MAINTENANCE BULLETIN

Alfa Company

<i>Page</i>	<i>Contents</i>
AUTOMOTIVE and CONSTRUCTION EQUIPMENT	
1	Points of Contact
7	Safety of Use - Dual Voltage Alternator Control (DUVAC)
12	Compactors May Overheat
12	HMMWV Hot Starts
12	Safe Booster Cable Operation
12	Brake Fluid Loves Water
13	Battery Basics
17	Summery of Confirmed MOD 97 Defective Material
SAFETY RECALL CAMPAIGNS	
3 & 4	Safety of Use - Firestone Tire Recall
14	Bendix ABS Recall
15	More Tires Included in the Firestone Tire Recall
18	Vehicle Recalls

Illustration 1

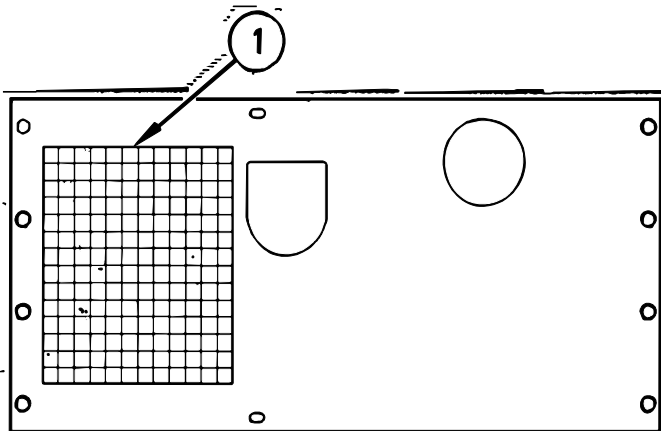
Description Of Change: Certain compactors may not have vent holes in the top panel.

Adaptable To: This change is effective for the 3TM1027-1073 and 2JM826-854 machines.

Inspect the top panel for vent holes (1).

If the vent holes are not present in the top panel, replace the panel with 180 - 5304 Top Panel.
